## STAFF RECOMMENDATION 3618 Meadowbrook Avenue February 17, 2021

**Application:** New Construction—Addition and Outbuilding  
**District:** Richland-West End Neighborhood Conservation Zoning Overlay  
**Council District:** 24  
**Base Zoning:** RS7.5  
**Map and Parcel Number:** 10405026400  
**Applicant:** Mitch Hodge  
**Project Lead:** Melissa Sajid, [Melissa.sajid@nashville.gov](mailto:Melissa.sajid@nashville.gov)

**Description of Project:** Project is to construct a rear addition that extends one foot, nine inches (1'-9") taller than the historic house and to construct an outbuilding.

Figure 3. 1931 Sanborn map.

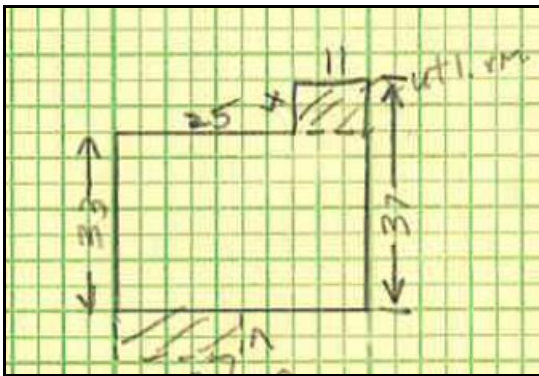
**Demolition:** The project includes the removal of an existing ten foot by ten foot (10' x 10') rear addition and a full width rear dormer (Figure 2). The 1931 Sanborn map shows a covered porch and part of the enclosed footprint at the rear of the house while the 1968 Property Assessor's card shows a fully enclosed four foot by eleven foot (4' x 11') utility room (Figures 3 and 4). A building permit issued in 2003 (200301878) permitted the addition of the rear dormer but specifically stated that the footprint was not expanded per that building permit. Given the available documentation, staff finds that the rear addition to be demolished likely was constructed between 1968 and 2003 while the rear dormer to be demolished was constructed c. 2003.

**1 SITE PLAN**  
1 1" = 20'-0"

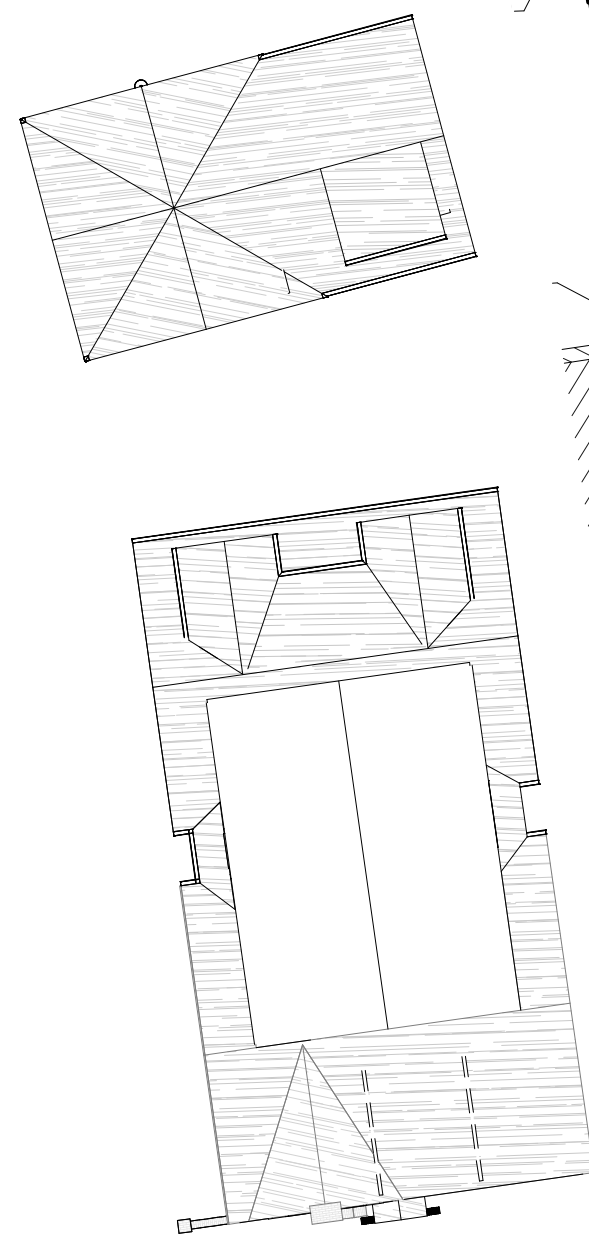
Setback & Rhythm of Spacing: The addition meets all base zoning setbacks as it is located approximately ten feet (10’) from the left-side property line, thirteen feet, six inches (13’6”) from the right-side property line, and fifty-six feet (56’) from the rear property line.

**Outbuilding:** The plans as submitted indicate that the outbuilding is intended to include a dwelling unit; however, since the base zoning is RS7.5, a DADU may not be allowed on this lot. Staff has advised the applicant to confirm the use with a zoning examiner since they determine if the use is permitted.

<b>MINIMUM</b>	<b>PROPOSED</b>
<b>Building located towards rear of lot</b>	-	Yes
<b>Space between principal building and Garage</b>	20’	21’
<b>Rear setback</b>	5’	10’
<b>L side setback</b>	5’	5’
<b>R side setback</b>	5’	6’-8”
<b>How is the building accessed?</b>	-	From the alley
<b>Two different doors rather than one large door (if street facing)?</b>	-	N/A

ELEVATIONS

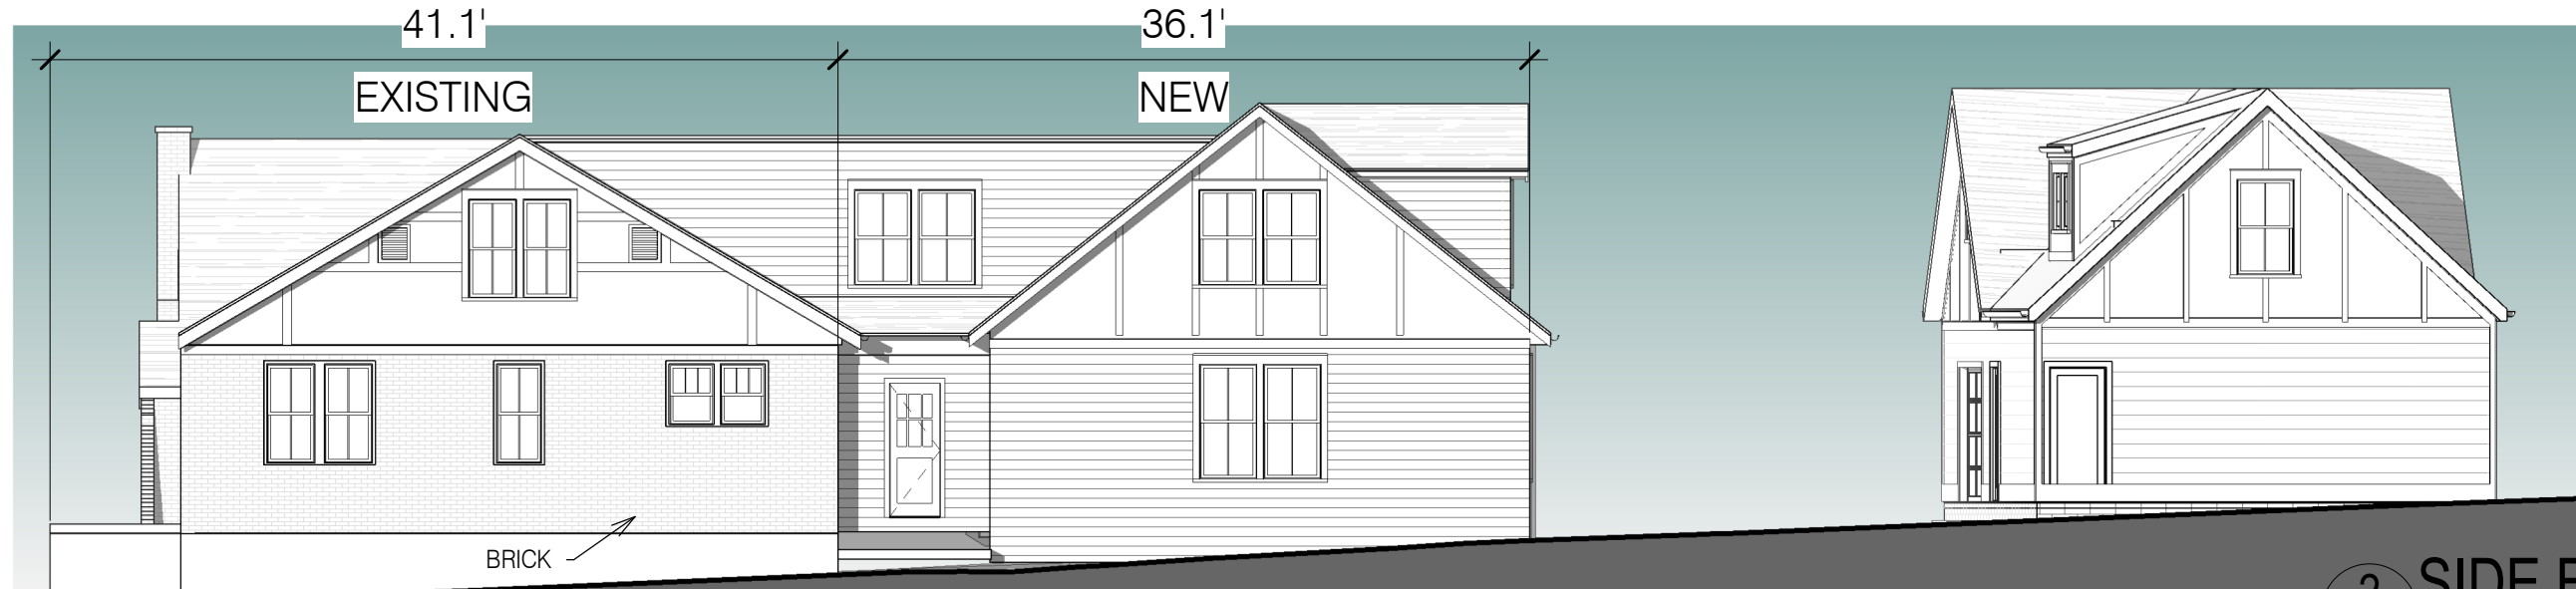
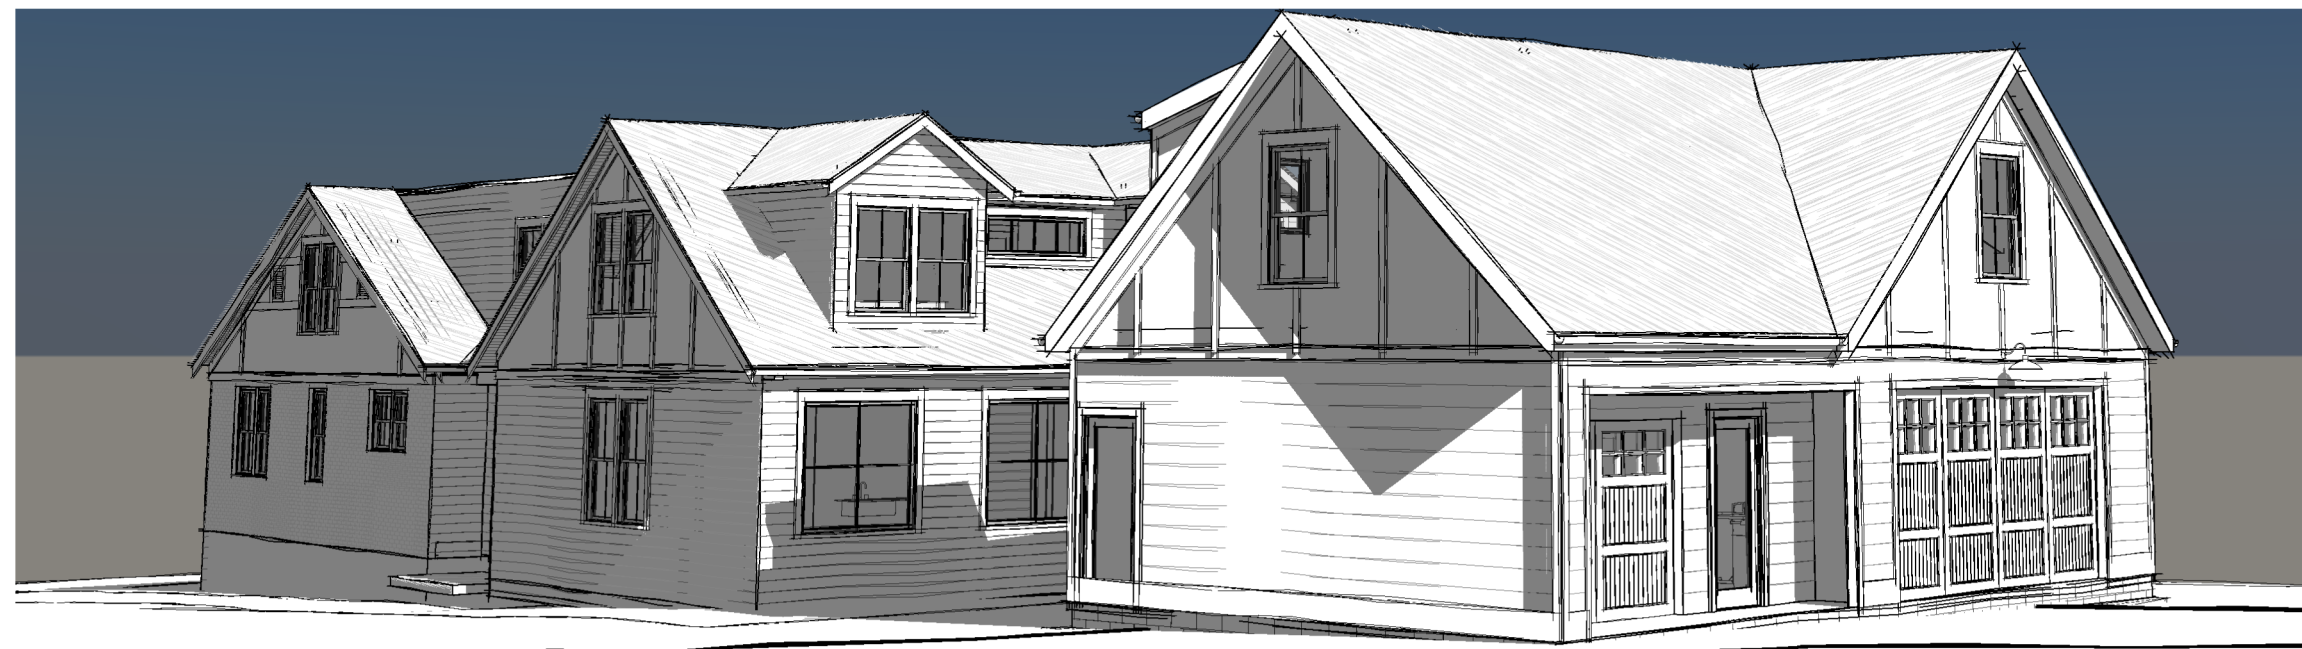
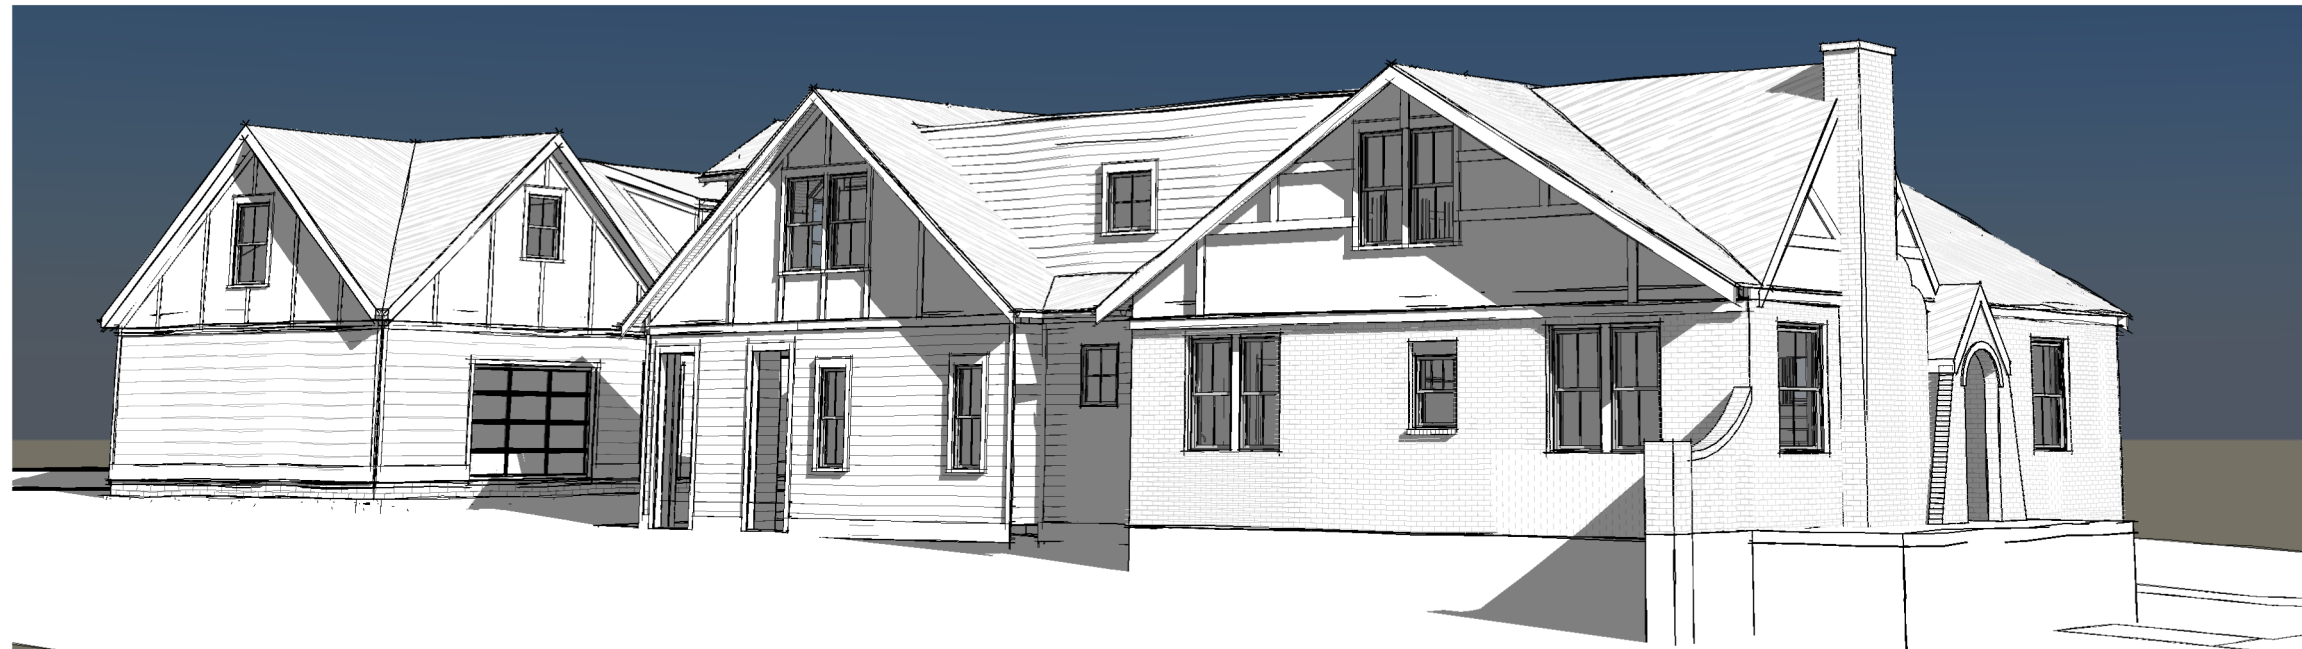
Height & Scale: The proposed addition does not more than double the existing footprint or extend wider than the historic house, but it does extend one foot, nine inches (1'-9") taller. The eave and foundation heights are no taller than the historic house. As proposed, the addition adds approximately one thousand, two hundred, seventy-two square feet (1272 sq. ft.) to the existing footprint of one thousand, three hundred, twenty-four square feet (1324 sq. ft.). The additional height occurs approximately fifty-eight feet (58') beyond the front wall of the historic house. Staff finds that the additional height meets the design guidelines since it occurs at least forty feet (40') behind the front wall of the historic house and does not exceed two feet (2') of additional height.

The addition is inset three feet, five inches (3'-5") on the right-side and two feet (2') on the left-side and the goes back eight feet (8') on both sides before coming back out to match the width of the historic house. The addition meets the design guidelines criteria for the addition to be inset a minimum of two feet (2') from the rear corners and for a structural alcove to be at least twice as deep as it is wide.

Design: The design of the addition is compatible with the historic house. It attaches to the roof of the existing house with a flat-roof connector that ties into a side-gabled roof form similar to that of the historic house. Staff finds that the flat-roof connector can be appropriate here since it is replacing an existing full-width dormer that has a similar roof form to what is proposed with the addition.

**Roof form:** The addition ties into the historic home with a flat roofed connector that transitions to a side gabled roof form with a pitch that is slightly steeper than the existing side gables on the historic house. Staff finds that the flat-roof connector can be appropriate here since it is replacing an existing full-width dormer that has a similar roof form to what is proposed with the addition. The rear of the addition incorporates a dormer that is set in two feet (2’) from the side walls which meets the design guidelines. Staff finds that the proposed roof forms and pitches are compatible with the existing house.

**Proportion and Rhythm of Openings:** No changes to the window and door openings on the existing house were indicated on the plans. The windows on the proposed addition are all generally twice as tall as they are wide, thereby meeting the historic proportions of openings. There are no large expanses of wall space without a window or door opening. Staff finds the project’s proportion and rhythm of openings to meet Section II.B.1.g.

With the condition that the siding have a maximum reveal of five inches (5”) and that staff approve the final selections of the foundation material, trim, roof color, windows, and doors, staff finds that the project meets Section II.B.1.d
